PROJECT TITLE : North Field East Project
Onshore LNG Facilities

TITLE : UPGRADE COLD BOX
GENERAL ARRANGEMENT-PLAN VIEWS
FOR UPGRADE AND EXPANDER
HELIUM LIQUEFIER / DISTRIBUTION SYSTEM

SCALE : 1:33		PROJECT NO. : LTC/C/NFE/3945/18		
PROJECT	DRAWING NO.	SHT	SIZE	REVISION
NFE1	3945-18-ME20829A-00282	1/3	A1	50

Onshore LNG Facilities of the NORTH FIELD EAST PROJECT					
Document Number	3945_18-ME20829A-00282	Document Revision	1	Document Title	UPGRADER COLD BOX - GENERAL ARRANGEMENT PLAN VIEWS FOR UPGRADER AND EXPANDER / HELIUM LIQUEFIER / DISTRIBUTION SYSTEM
Document Receipt Date		Review Code	B	Comments By :	
				Comment Date :	27-Mar-2023

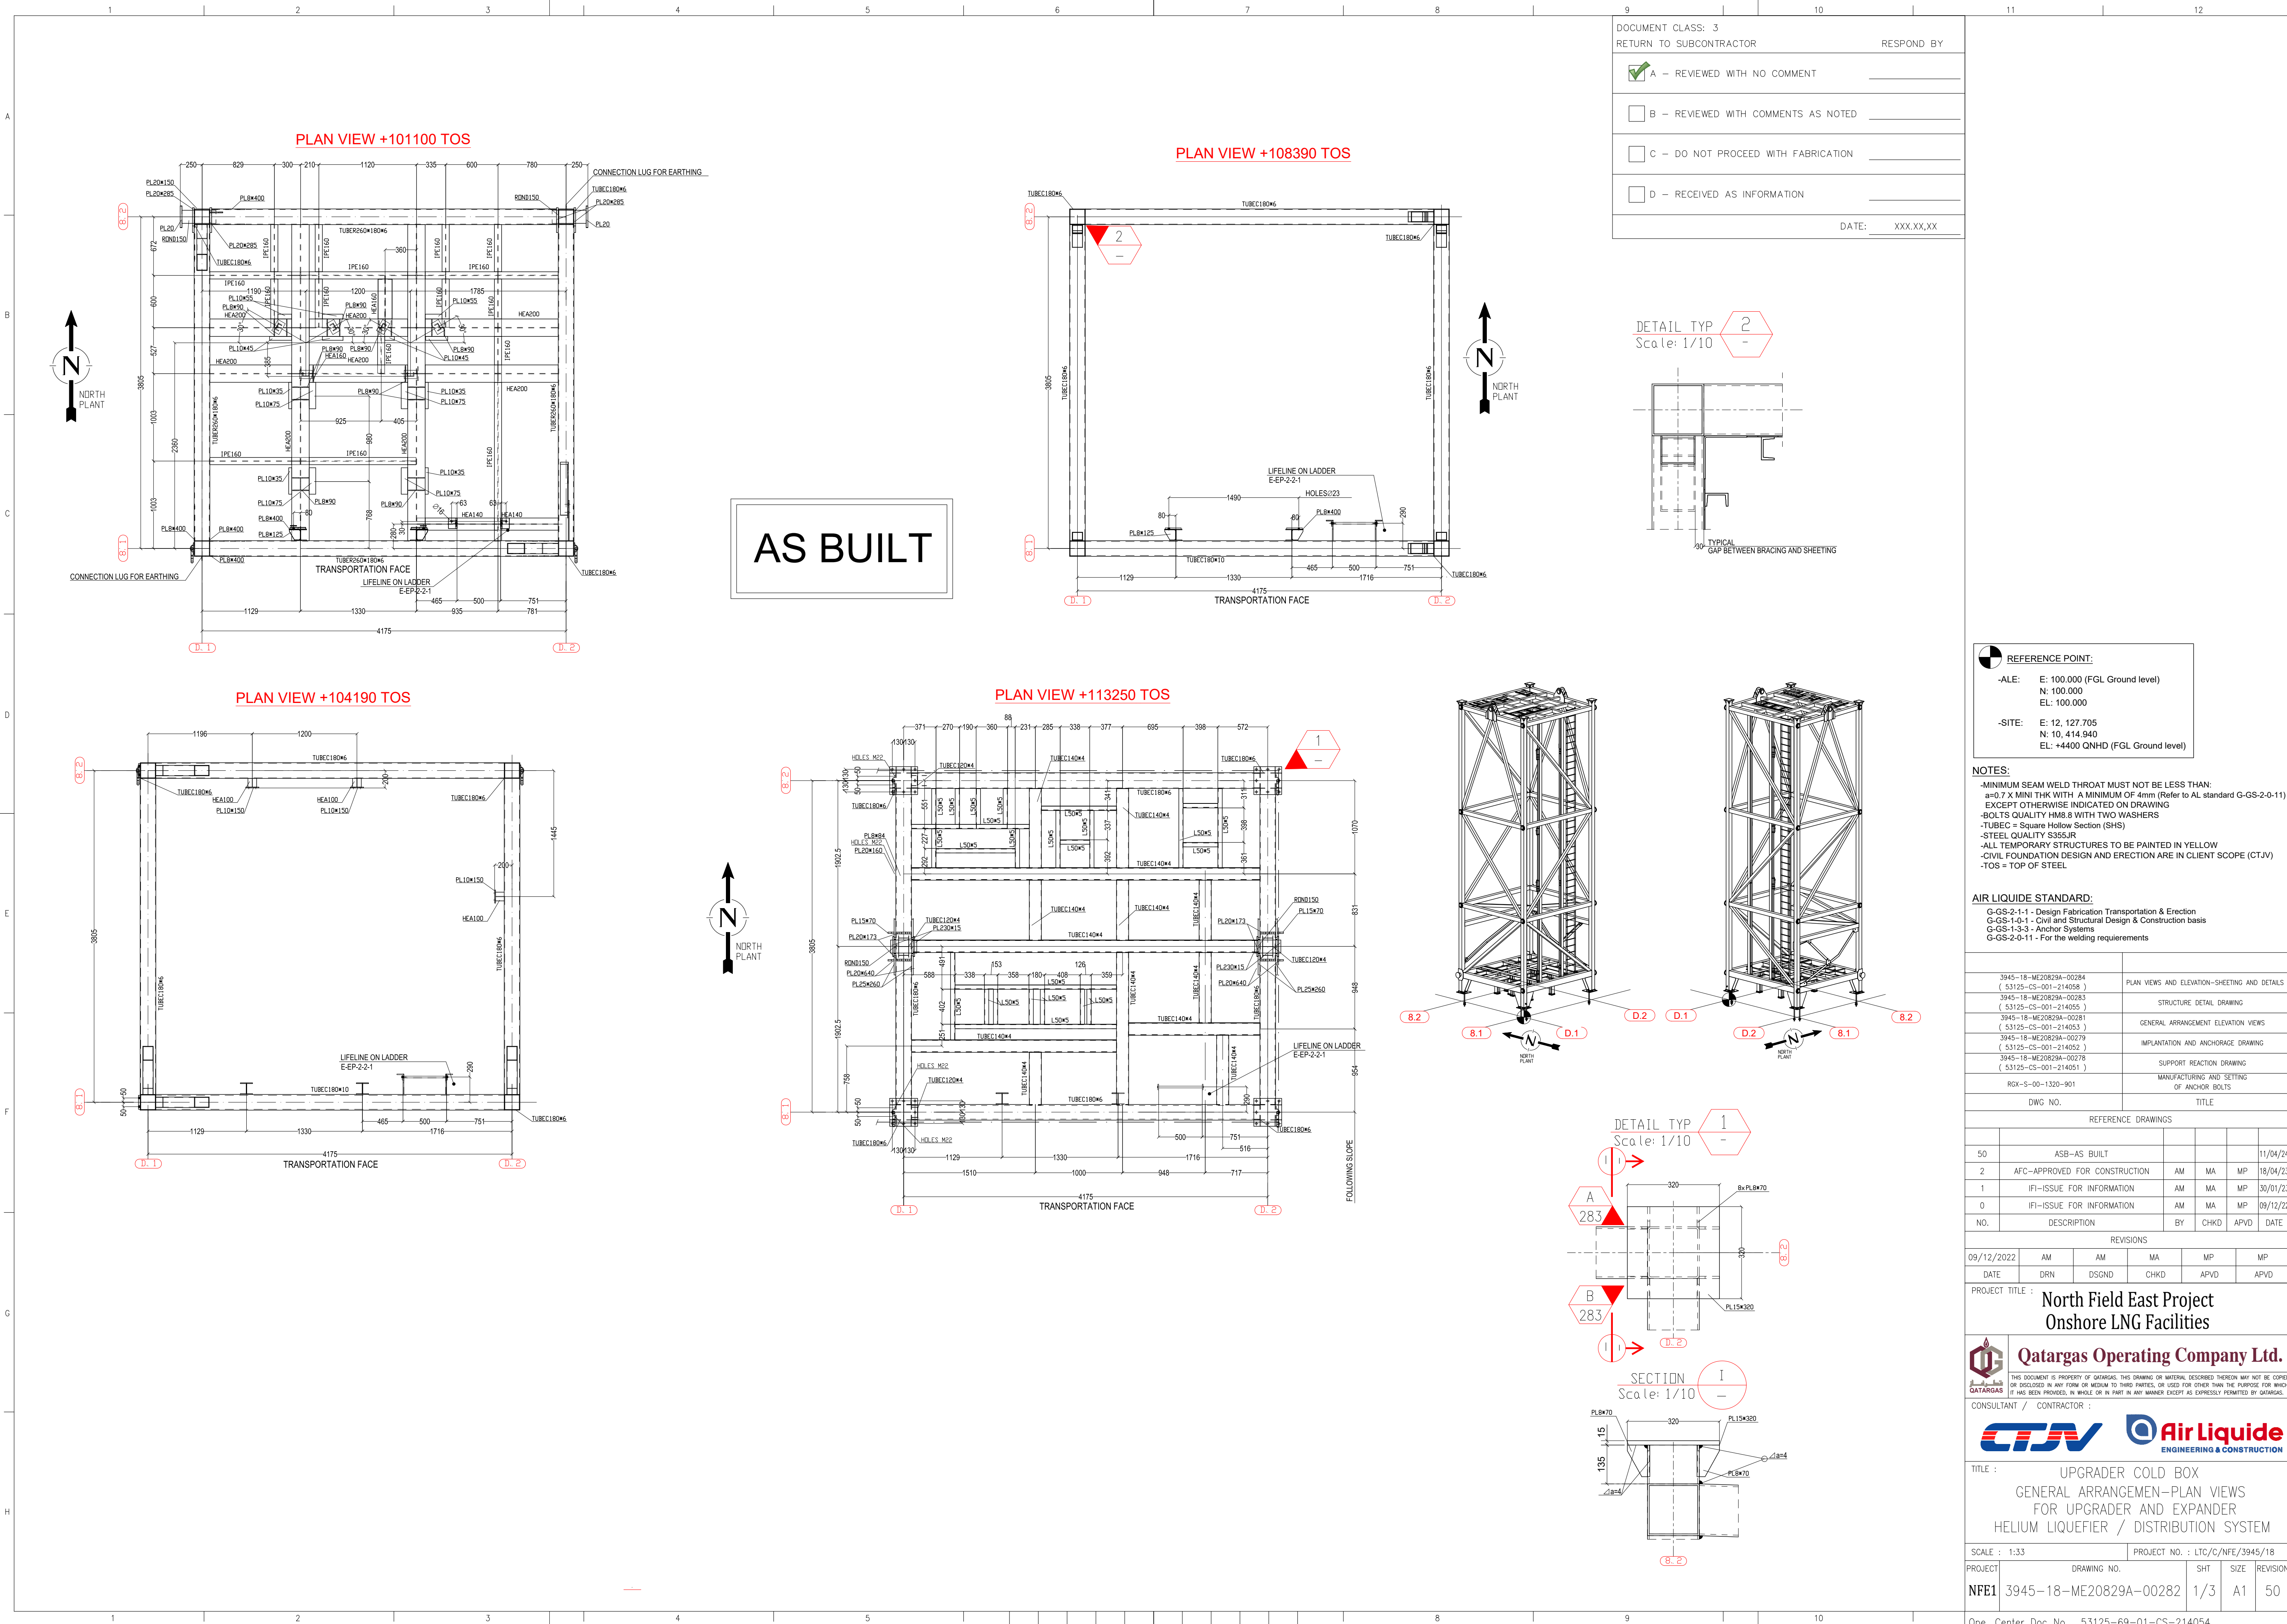
Comment Number	Discipline	Comment By	Section	CTR Comment	Reply by Air Liquide	Conclusion
1		vsivakumar1	1	COC-Civil Comment: Loads due to Turbine and platform to be considered in Cold box design	Rejected - As agreed during ALE/CTJV meeting, bottom platform shall be linked to the cold box structure in order to have a common independant structure (displacement cold box VS turbine is not allowed) => refer to email "RE: Piping/Civil workshop on upgrader." from O. Riffard dated on 10/02/2023	
2		dcastedo	1	A	All ALE documentation is based on this ALE grid system	
3		dcastedo	1	B	All ALE documentation is based on this ALE grid system	
4		dcastedo	1	A	All ALE documentation is based on this ALE grid system	
5		dcastedo	1	B	All ALE documentation is based on this ALE grid system	
6		dcastedo	1	1	All ALE documentation is based on this ALE grid system	
7		dcastedo	1	2	All ALE documentation is based on this ALE grid system

8		dcastedo	1	1	All ALE documentation is based on this ALE grid system	
9		dcastedo	1	2	All ALE documentation is based on this ALE grid system	
10		dcastedo	1	A	All ALE documentation is based on this ALE grid system	
11		dcastedo	1	B	All ALE documentation is based on this ALE grid system	
12		dcastedo	1	1	All ALE documentation is based on this ALE grid system	
13		dcastedo	1	2	All ALE documentation is based on this ALE grid system	
14		dcastedo	1	B	All ALE documentation is based on this ALE grid system	
15		dcastedo	1	1	All ALE documentation is based on this ALE grid system	
16		dcastedo	1	2	All ALE documentation is based on this ALE grid system	
17		dcastedo	1	A	All ALE documentation is based on this ALE grid system	
18		dcastedo	1	B	All ALE documentation is based on this ALE grid system	
19		dcastedo	1	A	All ALE documentation is based on this ALE grid system	
20		dcastedo	1	B	All ALE documentation is based on this ALE grid system

21		dcastedo	1	1	All ALE documentation is based on this ALE grid system	
22		dcastedo	1	2	All ALE documentation is based on this ALE grid system	
23		dcastedo	1	1	All ALE documentation is based on this ALE grid system	
24		dcastedo	1	2	All ALE documentation is based on this ALE grid system	
25		dcastedo	1	A	All ALE documentation is based on this ALE grid system	
26		dcastedo	1	B	All ALE documentation is based on this ALE grid system	
27		dcastedo	1	2	All ALE documentation is based on this ALE grid system	
28		dcastedo	1	2	All ALE documentation is based on this ALE grid system	
29		dcastedo	1	QNHD+12790mm	Equivalence of ALE reference system to QNHD system is already given in drawing

Comment Date :	27-Mar-2023	
30		dcastedo	1	QNHD+5500mm	Equivalence of ALE reference system to QNHD system is already given in drawing	
31		dcastedo	1	FGL+	Equivalence of ALE reference system to QNHD system is already given in drawing	
32		dcastedo	1	FGL+	Equivalence of ALE reference system to QNHD system is already given in drawing	
33		dcastedo	1	FGL+	Equivalence of ALE reference system to QNHD system is already given in drawing	
34		dcastedo	1	FGL+	Equivalence of ALE reference system to QNHD system is already given in drawing	
35		dcastedo	1	QNHD+8590mm	Equivalence of ALE reference system to QNHD system is already given in drawing	
36		dcastedo	1	QNHD+17650mm	Equivalence of ALE reference system to QNHD system is already given in drawing	
37		dcastedo	1	comments made on the previous have not been take in account please update. - GRID tag shall be inline with NFE project - Elevation to be in line with NFE projet, coordinates E100000, N100000,EL100000 have been agreed for ALE 3D model but for all dwg NFE elevation to be shown. please refer to FIVES dwg 00715 is already in QNHD, documents need to be homogenous. - vessel clips for the additionnal pltf and Pipes supports commented are missing please refer to the comment in dwg 281	- Equivalence of ALE reference system to QNHD system is already given in drawing - Elevations are fully compliant with the ALE 3D model - All external structures connected on the cold box (connection plates for platform structures and pipe supports) have to be welded on site by CTJV. Impact on cold box structure has to be checked by ALE based on input data provided by CTJV.

38		dcastedo	1	10,414.940	Accepted	
39		dcastedo	1	68-Y1201 upgrader have been moved 4m toward north, informed during meeting held in november 2022 and already shown in the 3d share with ALE but no impact for your design.	Accepted	
40		dcastedo	1	origine of equipment its on the bottom of the base plate E 12,127.705 N 10,414.940 EL QNHD+4600	Origin / reference point is based on ALE 3D model: E:100.000 = E:12,127.705 N:100.000 = N:10,414.940 (will be modified based on information from CTJV) EL:+100.000 = EL:+4400 QNHD (FGL ground level)	
41		dcastedo	2	NOT ACCEPTABLE, BRING DOCUMENT IN NFE STD	Equivalence of ALE reference system to QNHD system is already given in drawing	
42		dcastedo	2	NOT ACCEPTABLE, TAG OF GRID TO AS PER COMMENTED	All ALE documentation is based on this ALE grid system	
43		cbiellmann	2	1 : not accepted NFE elevation to be shown, we have agree for the 3d model of ALE to have coordinate E100000, N100000, & EL100000 but in dwg all elevations shall be as per NFE data.	Equivalence of ALE reference system to QNHD system is already given in drawing

44		dcastedo	2	not accepted - see 1	Equivalence of ALE reference system to QNHD system is already given in drawing	
45		dcastedo	2	not accepted - see 1	Equivalence of ALE reference system to QNHD system is already given in drawing	
46		dcastedo	2	not accepted - see 1	Equivalence of ALE reference system to QNHD system is already given in drawing
